CONSTRUCTION DOCUMENTS  
GRANDVIEW RESERVE FILING NO. 1  
4 SITE INVESTMENTS, LLC (D.R. HORTON)  
SF-22-XXX  
EASTONVILLE RD & REX RD  
EL PASO COUNTY, FALCON, CO 80831

OVERALL SHEET

MILL YARD CIR (D) - PUBLIC 50' R.O.W.  
25 MPH DESIGN SPEED (LOCAL)  
SCALE: 1"=30'

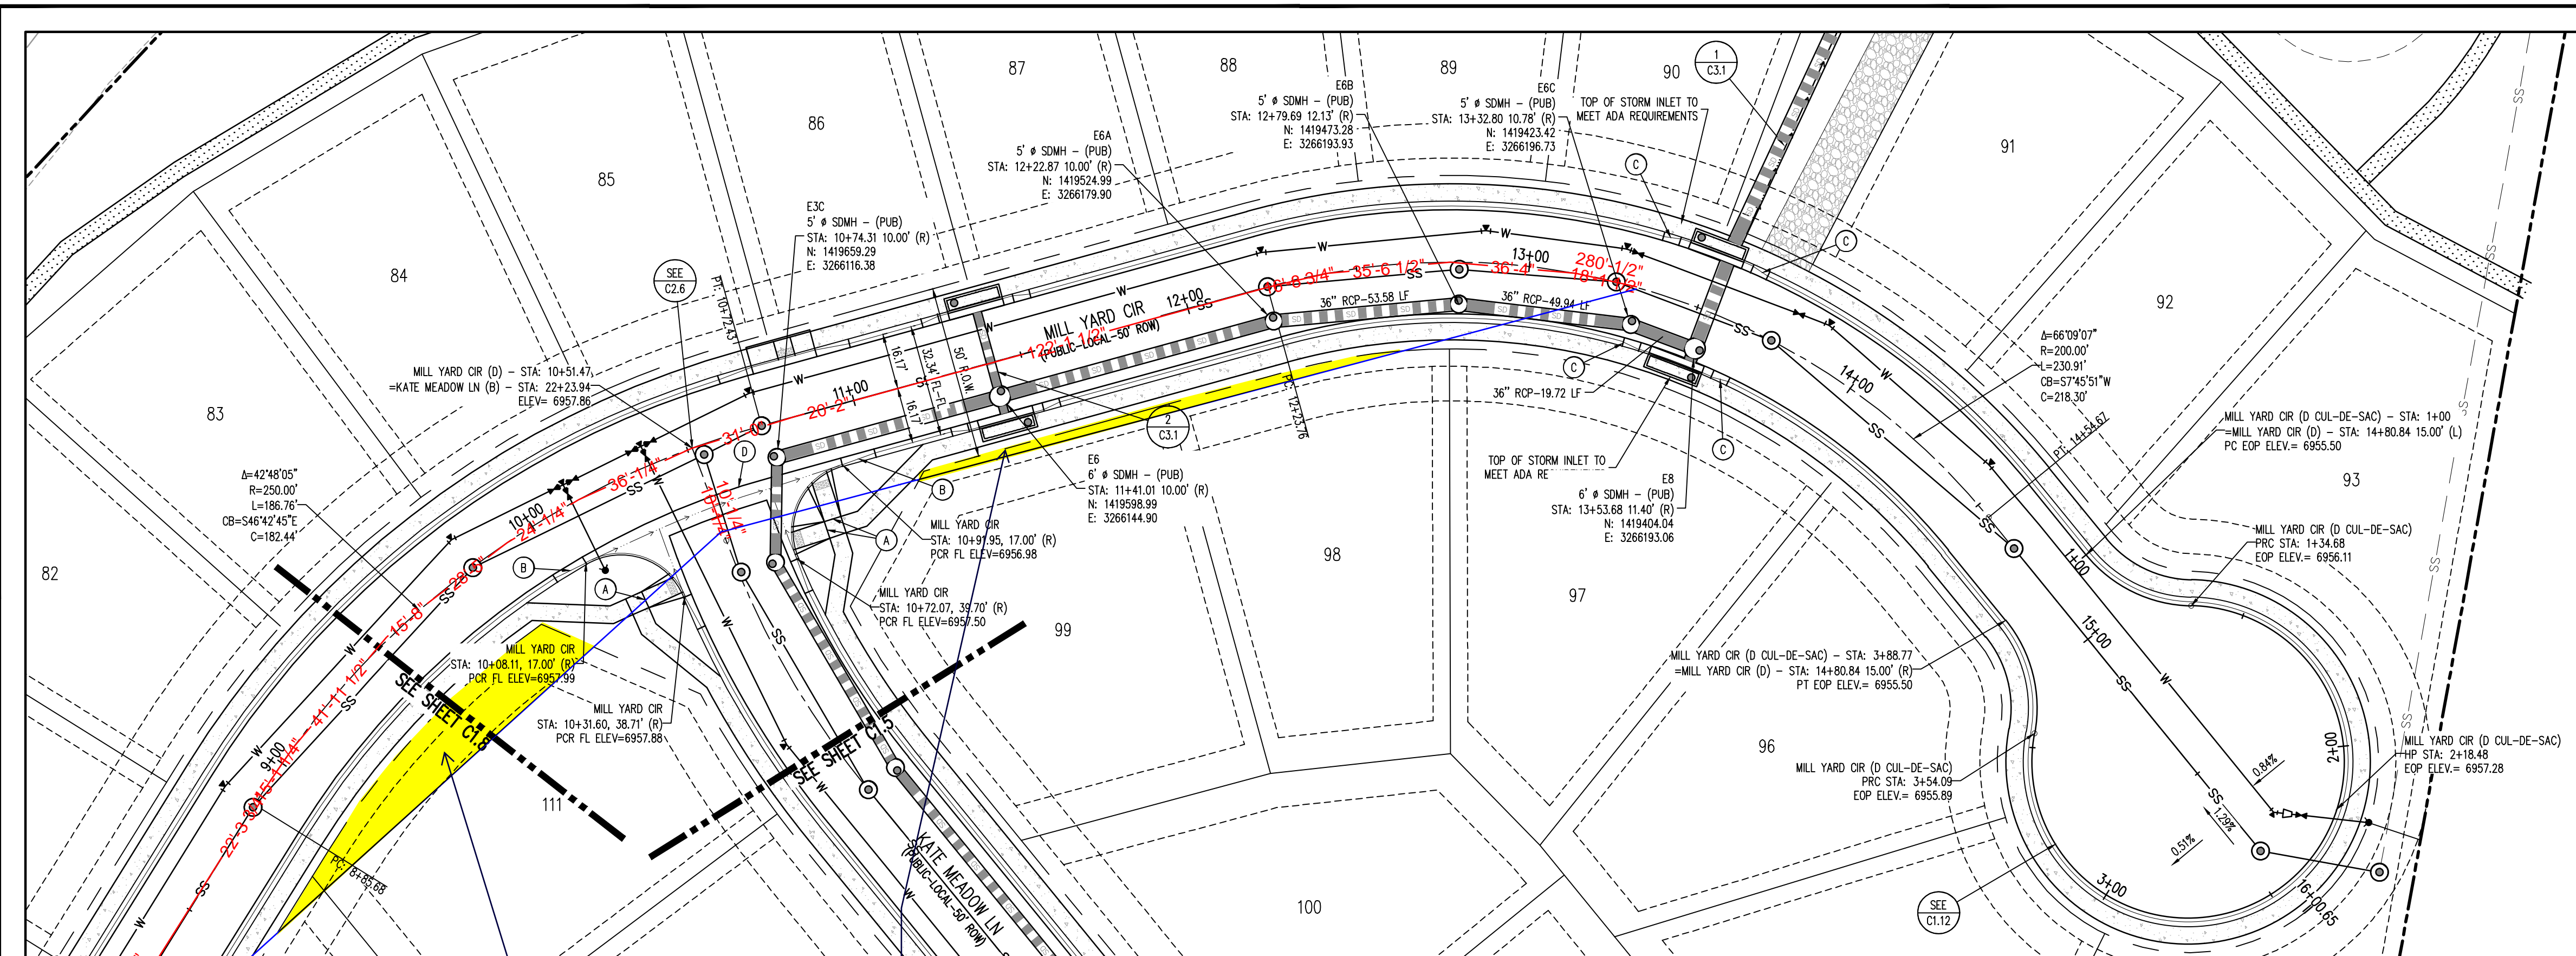
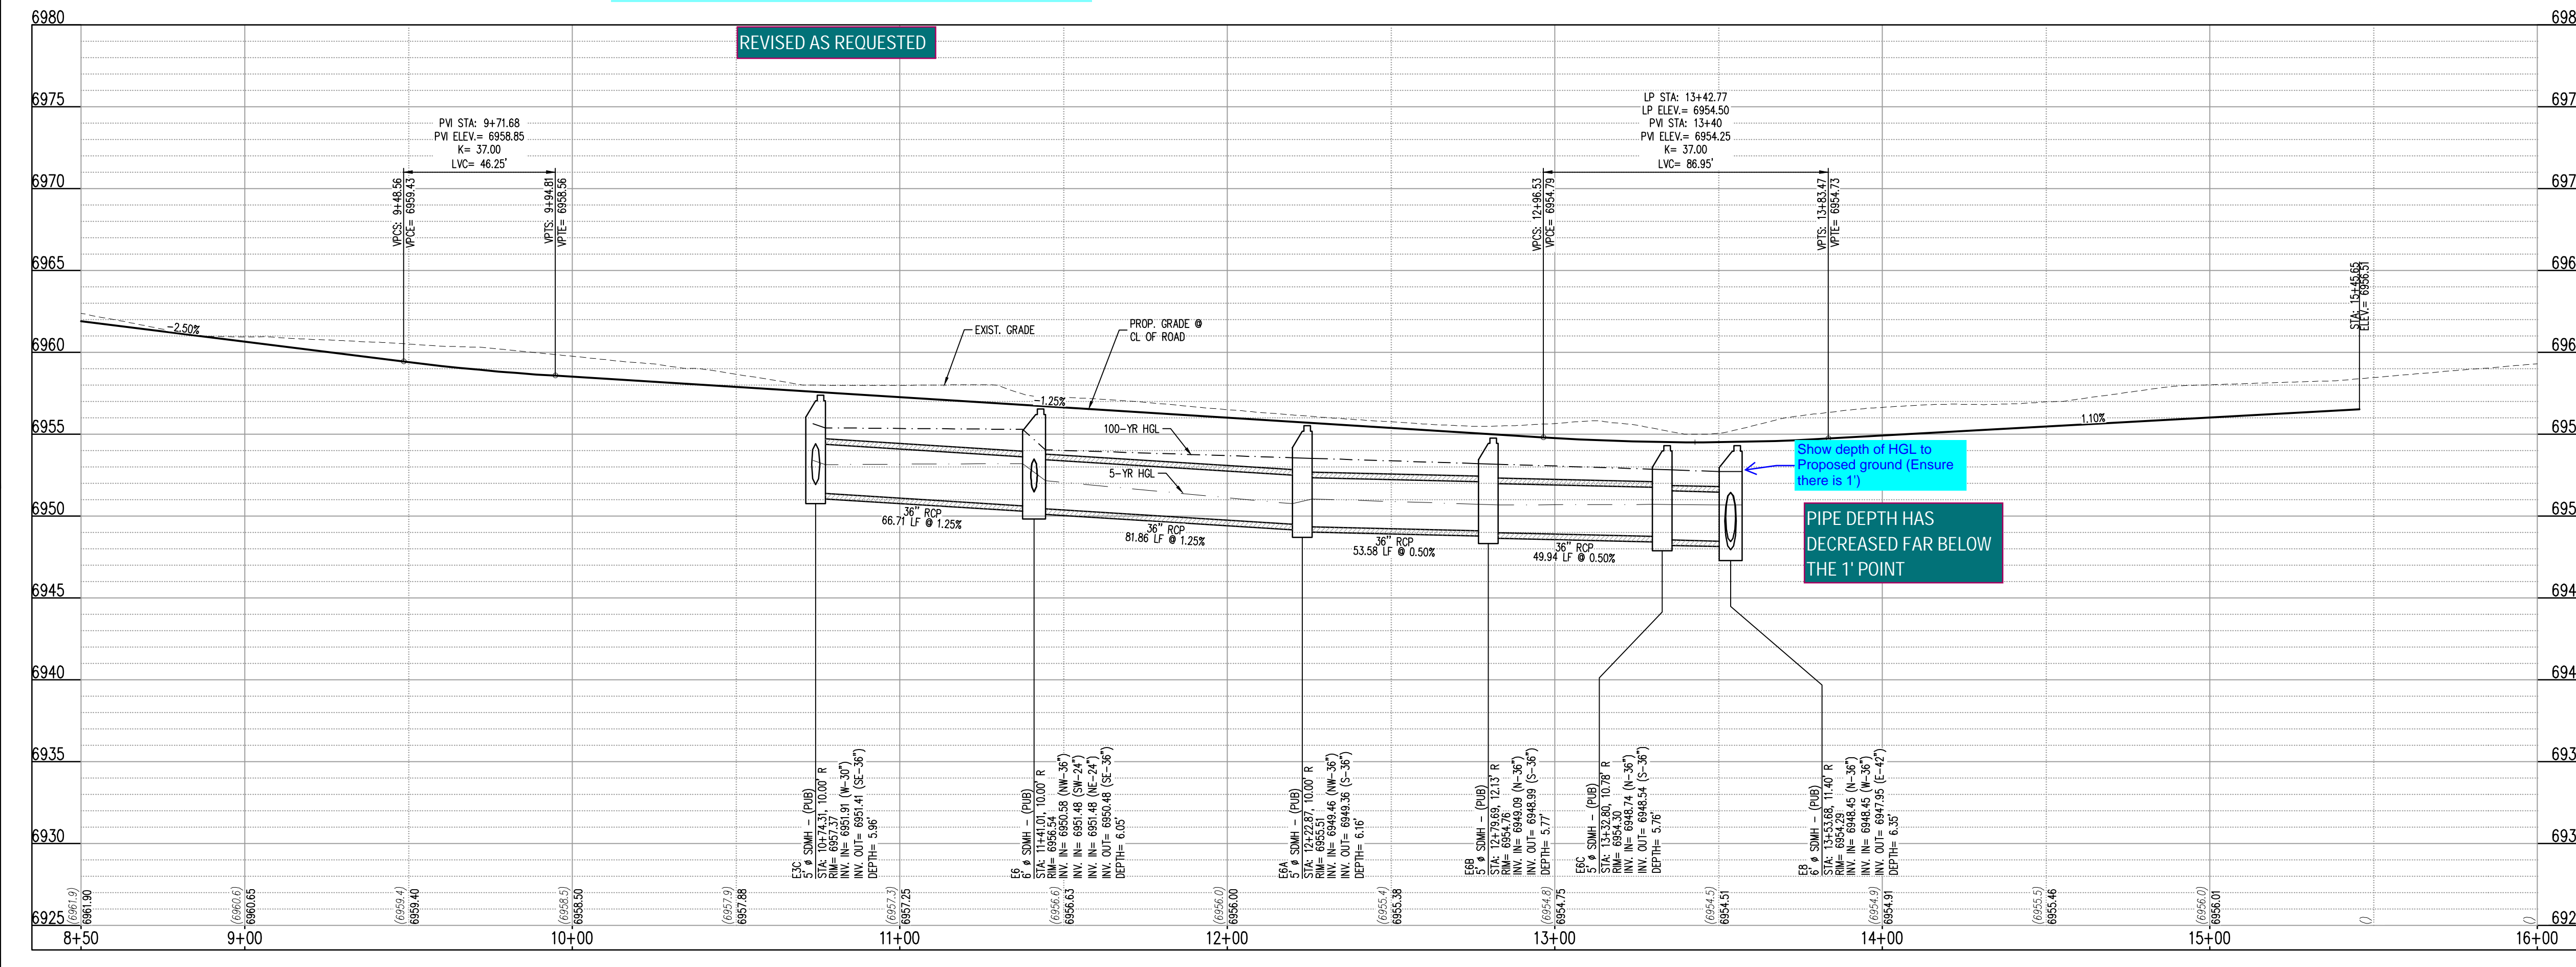
Show the line of sight per ECM Table 2-21.

Update the plat to identify the area within private property as "sight distance easement" and add a plat note stating the following:

Any object within the sight distance easement more than 30 inches above the flowline elevation of the adjacent roadway shall constitute a sight obstruction, and shall be removed or lowered. The objects may include but are not limited to berms, buildings, fences, parked vehicles on private property, cut slopes, hedges, trees, bushes, utility cabinets or tall crops. Maintenance of a sight easement shall be the responsibility of the \_\_\_\_\_ [property owner or HOA or District].

Show depth of HGL to Proposed ground (Ensure there is 1')
